FIELD SERVICE BULLETIN

FSB Number: FSB-015

Title: Switch Mode Power Supply

System Description: All 1200 series projectors

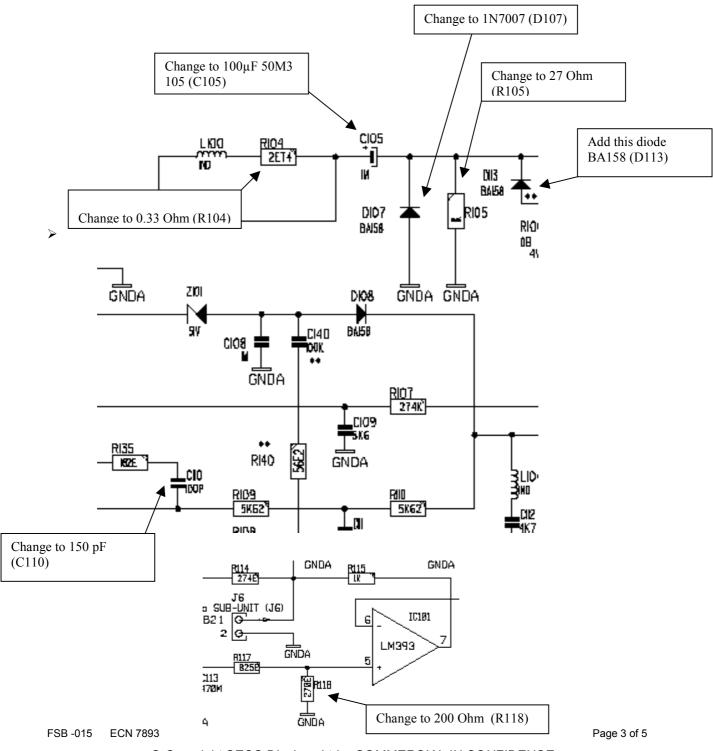
Instructions for replacing IXTH12N100 → 2SC3998

- ➤ Remove the Mosfet IXTH12N100. Take care to carefully clean the holes, this will facilitate the insertion of the leads of the new transistor. Do not mount the new transistor untill you have replaced the other components listed below (To enable better access).

- ➤ D107 (BA158) is replaced by a 1N4007 (C131646)
- ➤ Add diode D113 BA158 (V131637) between base and emitter of Q100. Clear the holes on the printed circuit and position the diode as printed on the board (The printed circuit is ready for mounting this diode).

- > R104 (2E74F) has to be replaced by a E33J, 0W6 (V102499).
- ➤ R105 (1k) has to be replaced by a 27E4 F 0W6 (V1026424).
- ➤ Check C110, it must be 150pF (V1122842).

- \triangleright C105 (1µF) has to be replaced by a 100µF (V1114874).
- ➤ R118 (270E) has to be replaced by a 200E 0W6 (V1026295).
- Mount the new transistor **2SC3998** (B133124) in the same holes as the MOSFET.

✓	Transistor Q100	2SC3998,	B133124
✓	D107	1N4007	C131646
✓	D113	BA158	V131637
✓	R104	0.33 Ohm	V102499
✓	R105	27 Ohm	V1026424
✓	C110	150pF	V1122842
✓	C105	100μF 50M3 105	V1114874
✓	R118	200 Ohm	V1026295

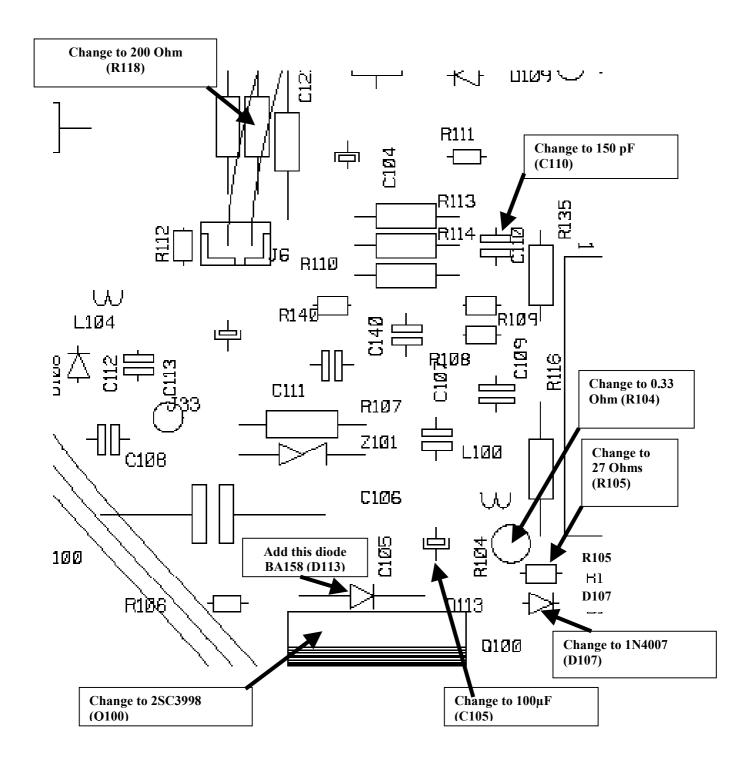
Instructions for replacing BUP101 → 2SC3998

All that is required for this modification is to replace C110 (1n2) with a 150pF (V1122842)

New fixation for transistor securing bracket

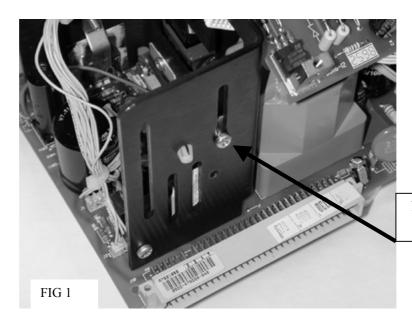
- ♦ NB The body of the 2SC3998 is much larger; and as a consequence, the same hole in the heatsink can no longer be used for securing the bracket supporting the MOSFET. It will need to be mounted higher. The cutout on the heatsink above the original hole can be used for mounting the stainless steel bracket to support the new device (see picture 1)

- Shift the mica insulator upwards to guarantee good insulation from the heatsink
- Apply some heatsink compound to improve the thermal contact with the heatsink.
